SERVICE BULLETIN No. 292 79 2230

Version: B

Subject:
Oil system - Improvement of the oil pump sealing.
Modification TU 230.

1.1.1. Context

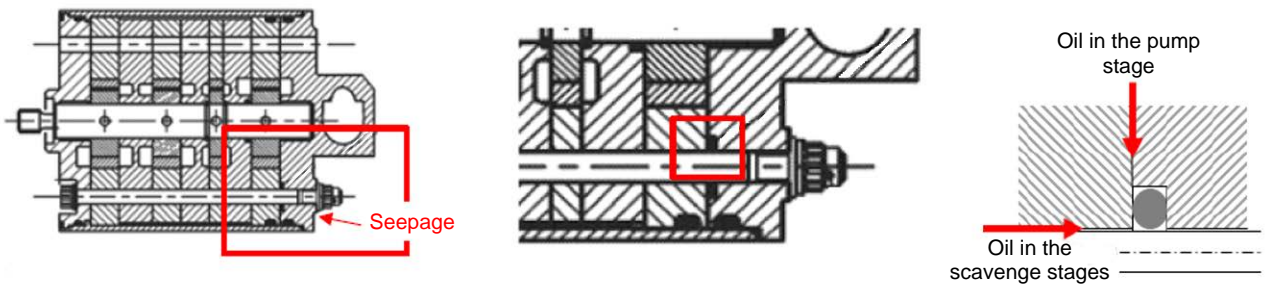
An integrator customer found oil seepage coming from the ARRIEL 2 oil pumps.

The seal on the calibrated screws of the oil pumps is in an axial sealing configuration.

This seal elongates radial sealing when this seal is positioned on the calibrated screw.

Tests showed that it is possible that this elongation is not sufficient and that it can cause oil seepage.

1.1.3. Solution

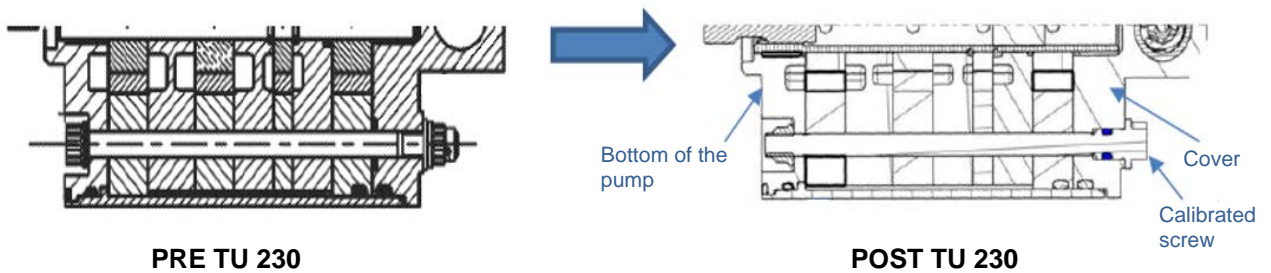
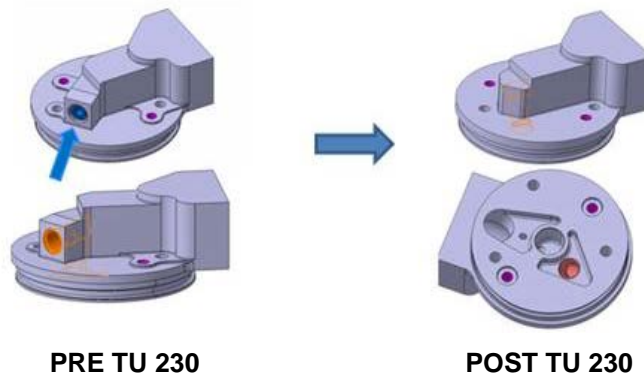
Modification TU 230 is a change in the sealing design of the calibrated screws, as the seal groove housing is now on the screw. The cover and the bottom of the pump are fitted as necessary.

In addition, the cover is changed and then a plug is no more necessary (and this prevents possible seepage).
